Preliminary responses to OEH and SEWPaC comments on the Preferred Project
Report and Response to Submissions — biodiversity (26 March 2013)

Re: Cobbora Coal Project – Preliminary Responses to OEH and SEWPaC Comments on the Preferred Project Report and Response to Submissions – Biodiversity

DATE: 19/3/2013
MEMO TO: Department of Planning and Infrastructure – Stephen O’Donoghue
FROM: Gavin Heydon
SUBJECT: CLARIFICATION OF TAILINGS INFORMATION
REFERENCE:

The purpose of this addendum is to correct the results presented in Appendix E that were affected by a water balance model error, and to discuss the wider implications of the error for the Surface Water Assessment and Environmental Assessment. In addition, further information is provided in the addendum on additional model sensitivity analyses undertaken to address a concern of the DP&I's reviewer regarding the reliance of the mine on the surface water entitlement from the Cudgong river source. Specifically, the reviewer raised the concern that the volume of groundwater inflow to the mine pits available for use in the mine water management system may have been overestimated.

Figure A1.1 – Water balance for SD1 for mine stage year 4 and 90th percentile rainfall (wet) year of 1990 (plot 1 of 3)

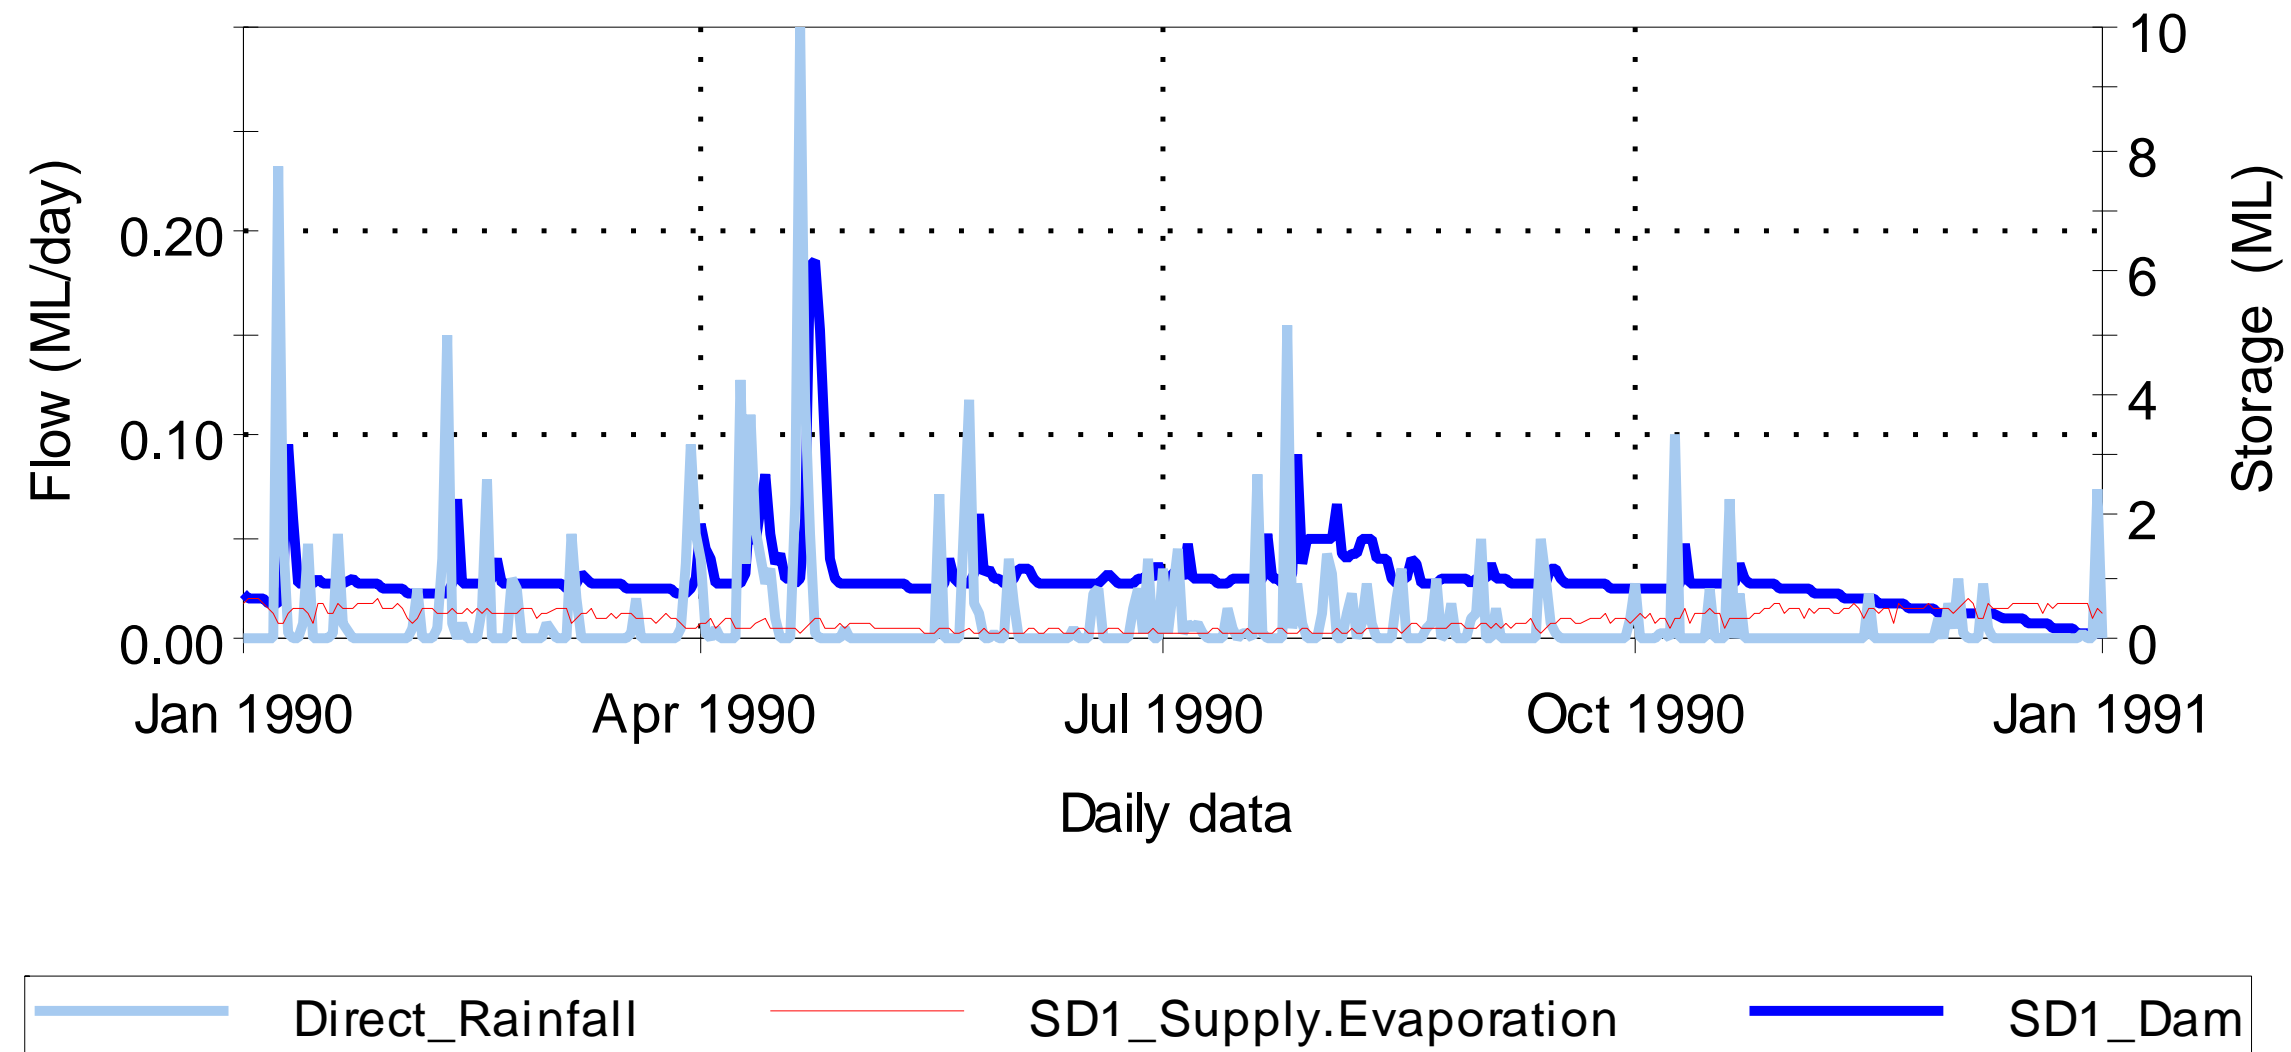
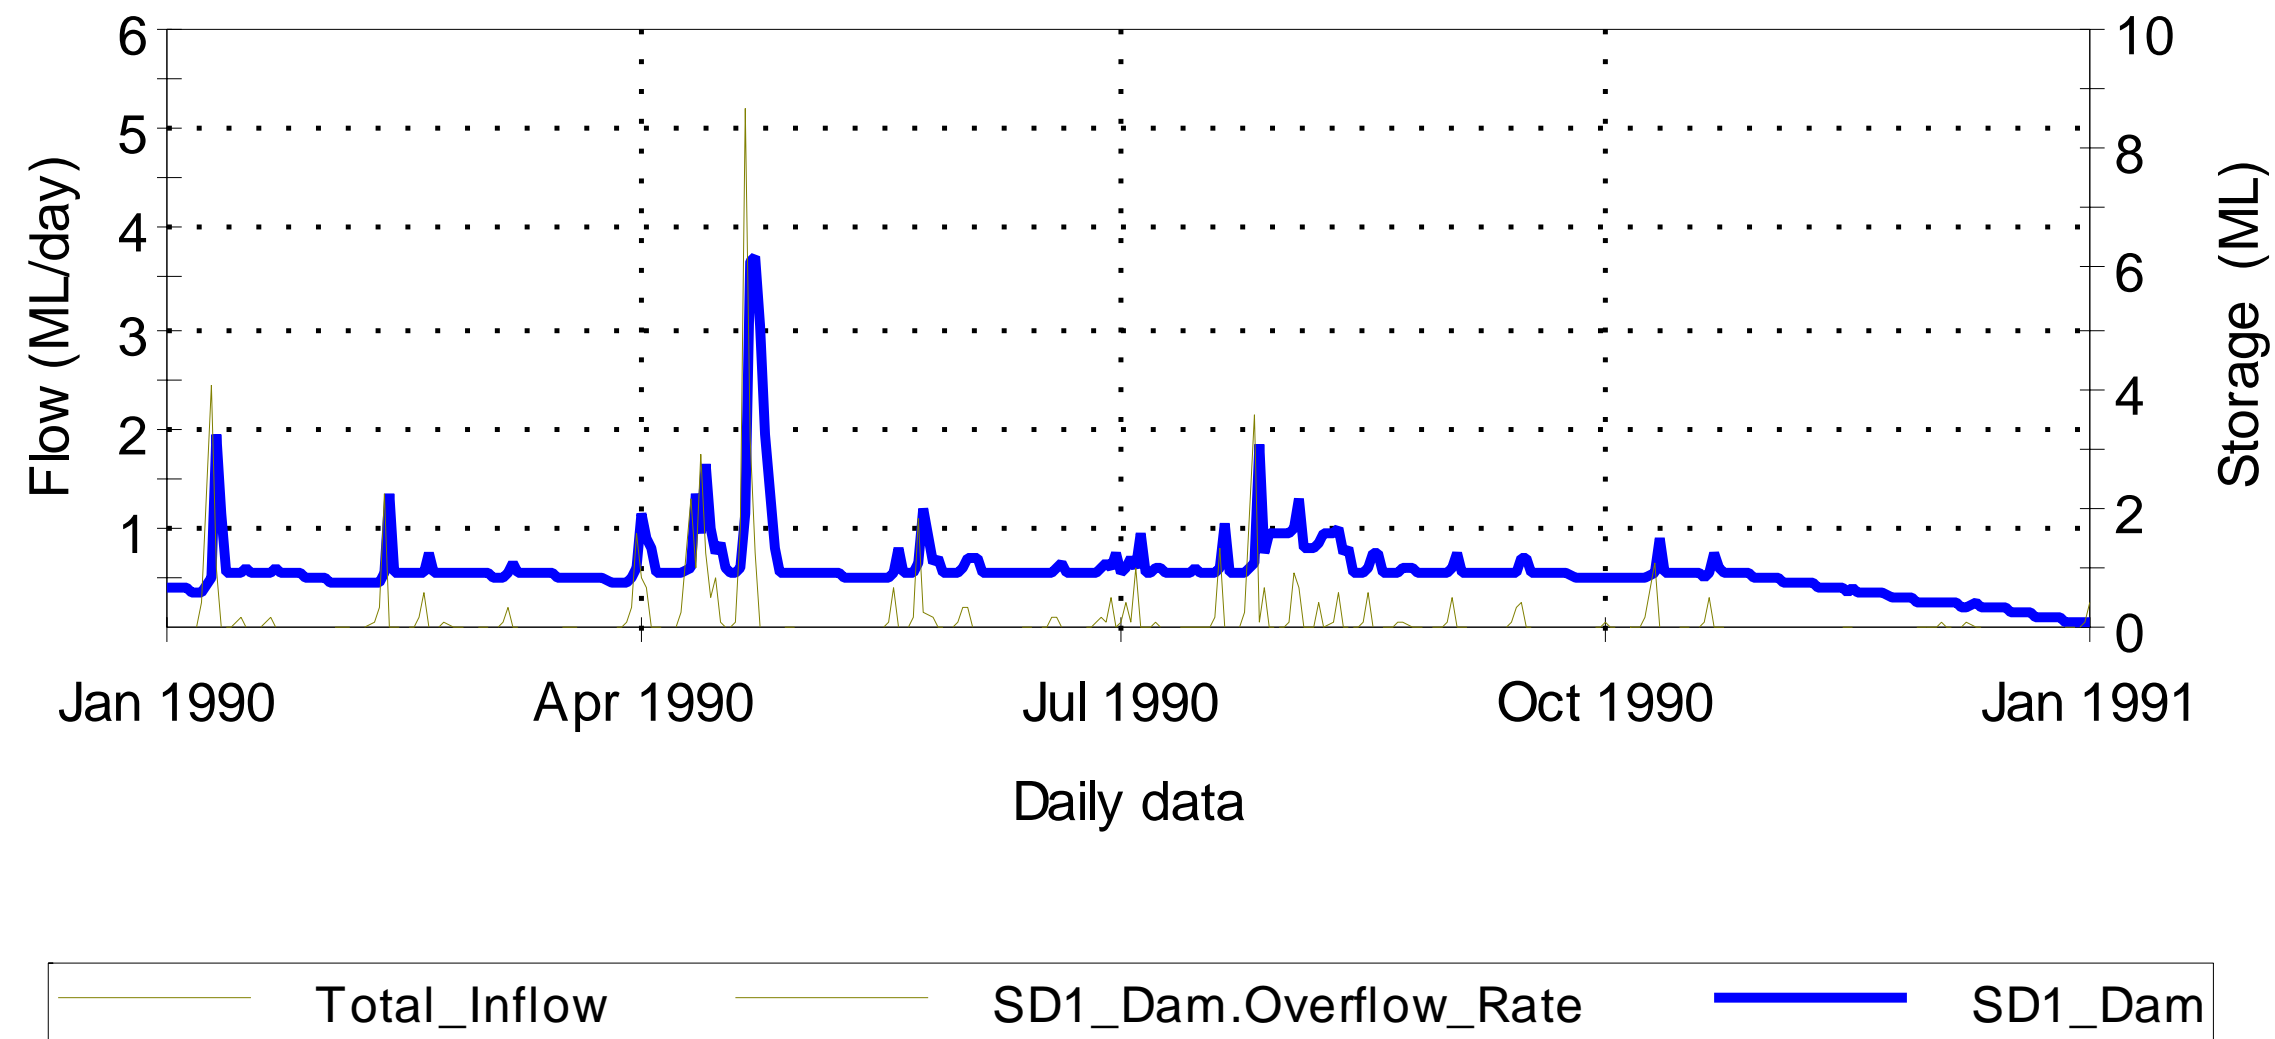
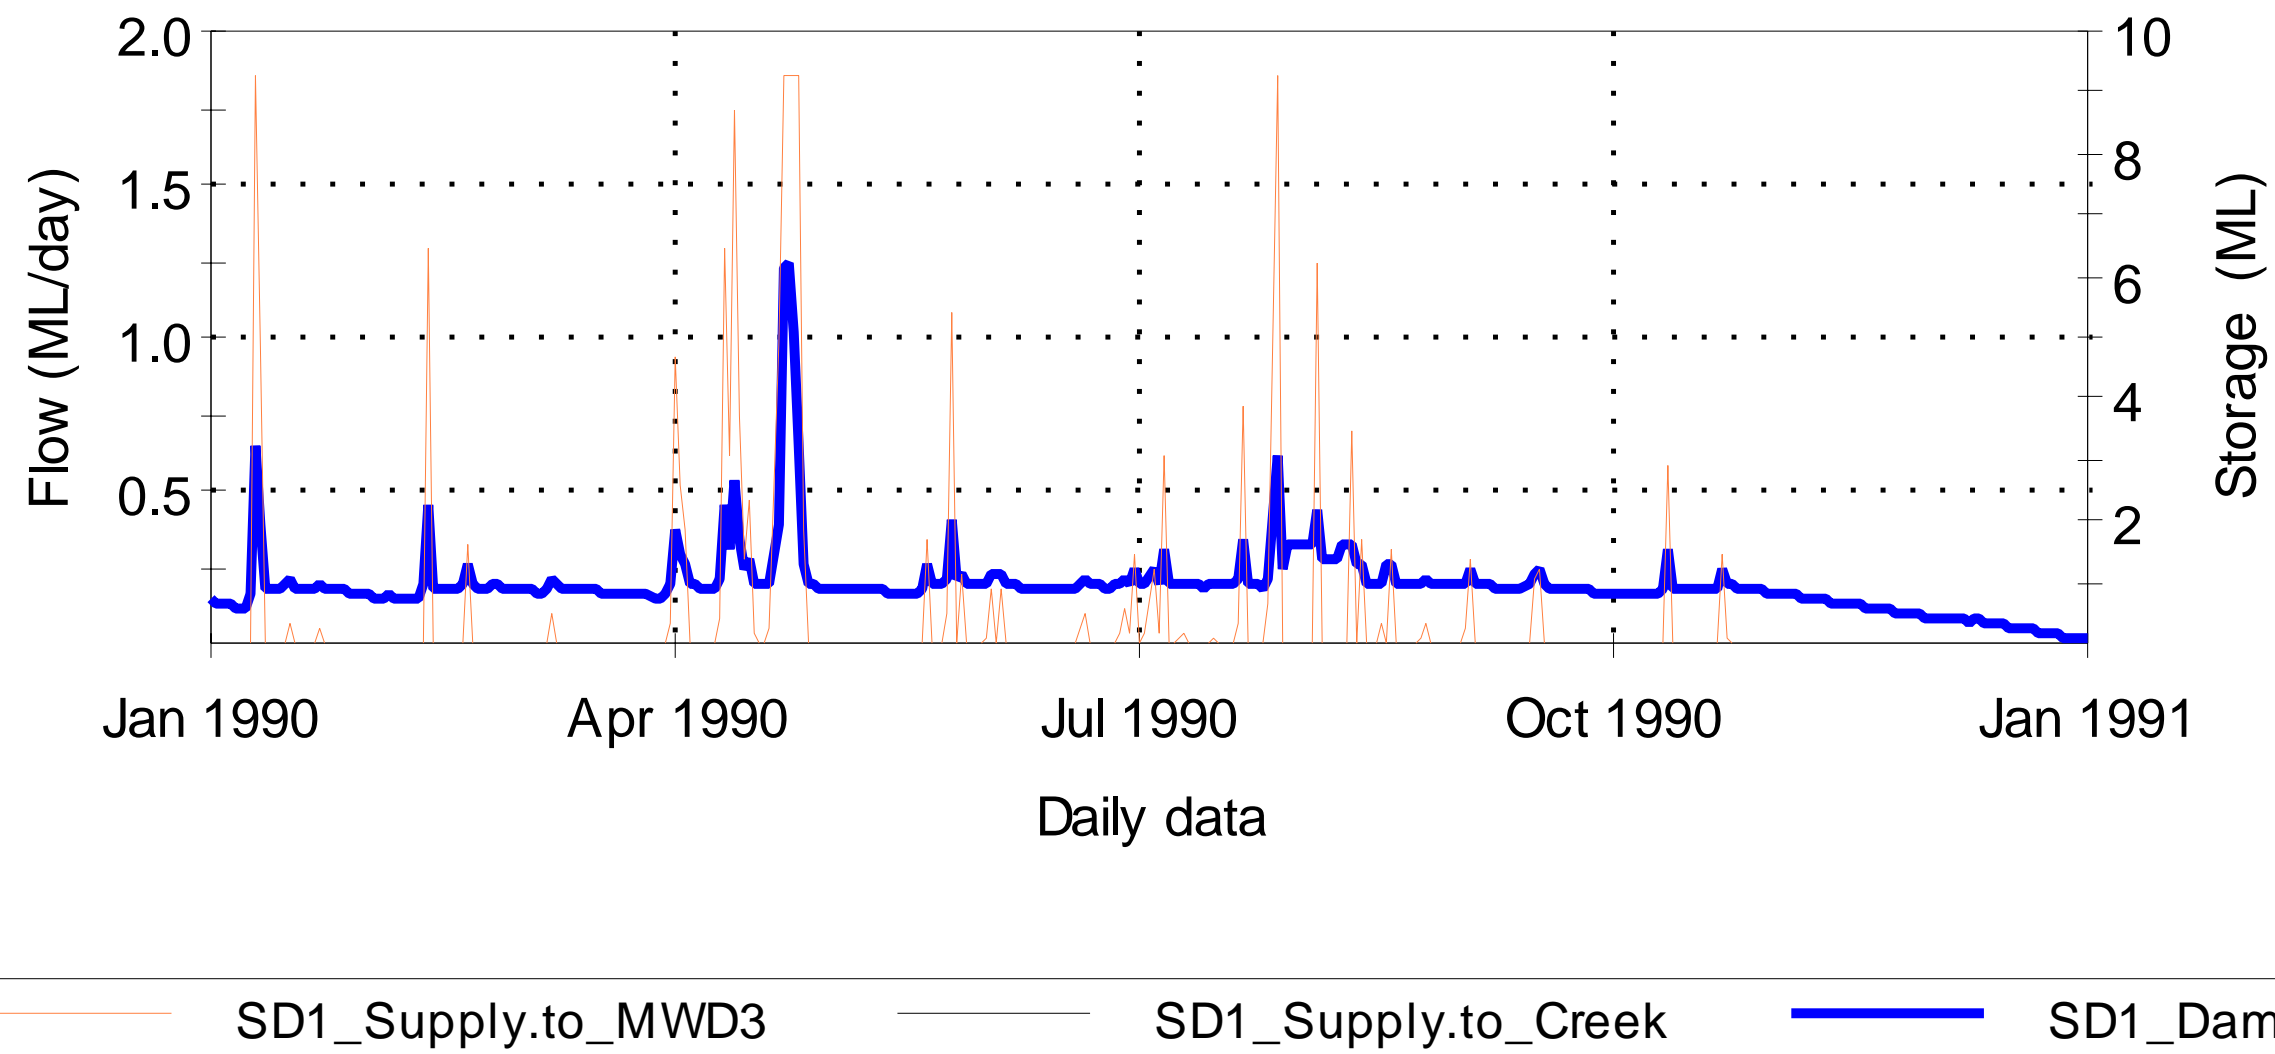
Figures A1.1 to A1.3 show the daily simulation for SD1 for 1990 (wet) conditions. The figures illustrate that whenever the rainfall-runoff raises water volumes greater than half of the SD1 sedimentation volume, water is pumped to MWD3. Below this storage level only evaporation occurs and no other supplies are made from this dam. No overflows from SD1 occurred as the final volume never exceeded the maximum water holding capacity of SD1 (see Table 1).
